SAFETY RECALL

Date	Number	Release	Page
06.2025	SC0480	01	1(9)

Improper Power Cable Routing AN,GR

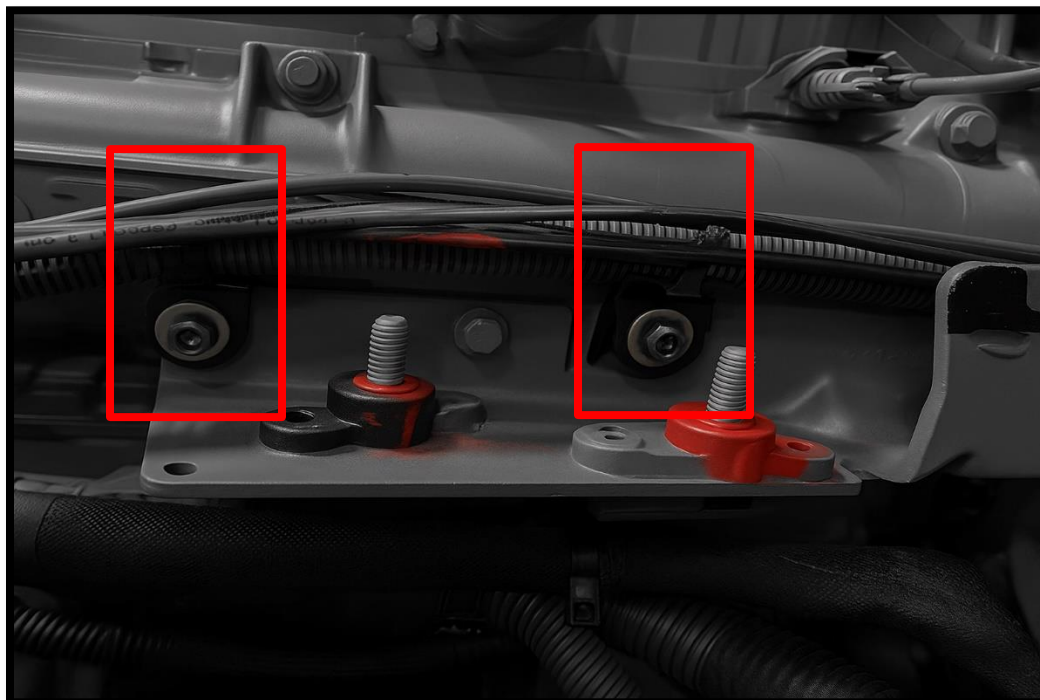
14. Install the Zip-Tie bracket (P/N 21400204), M6 Flange Screw (P/N 984726), and Flange Nut (P/N 990949) in the locations pictured below.
15. Install Zip-Ties and secure the cables and wiring that run above the power and ground terminals.

Ensure all cables and wiring above the terminals are secure and that no contact with the terminals is possible.

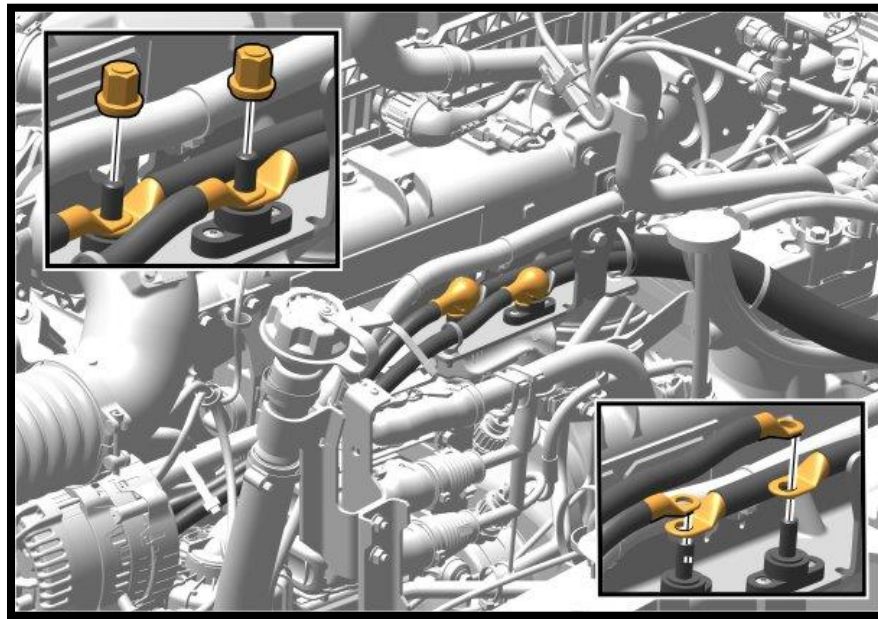
When torquing the cables, ensure they do not twist or rotate into each other, as this may cause contact with the opposing terminal. Verify that there is adequate spacing between the cables and opposing terminals to prevent accidental contact or electrical faults.

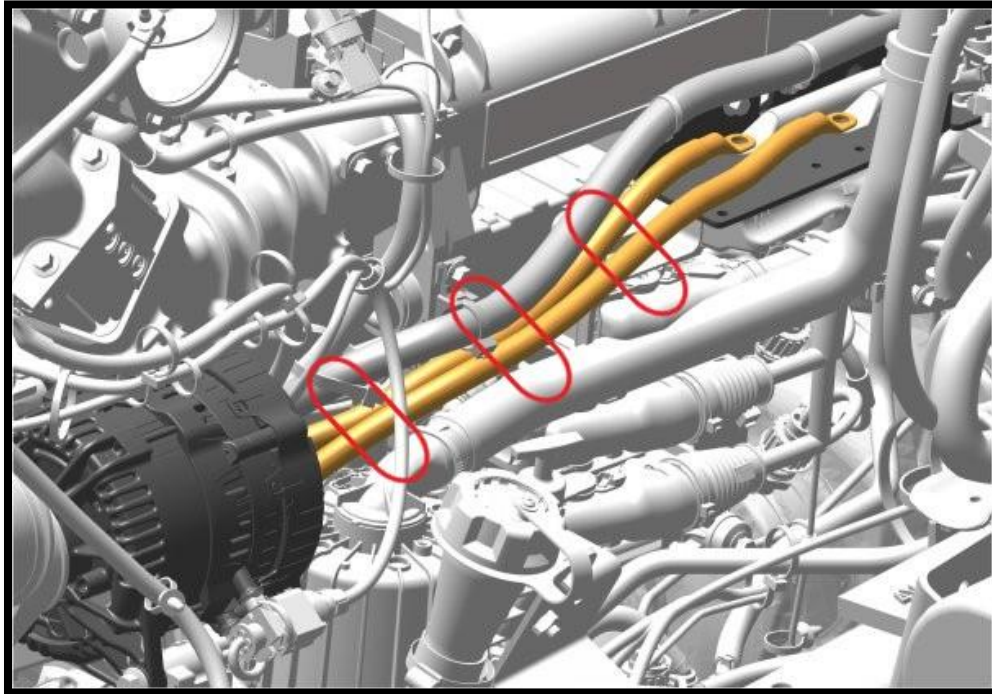
20. Install double headed zip ties (P/N-20395795) in the locations pictured below.

Ensure there is sufficient spacing between opposing cables, that all cables are securely fastened, and that they do not come into contact with any components that could cause damage to the cables.
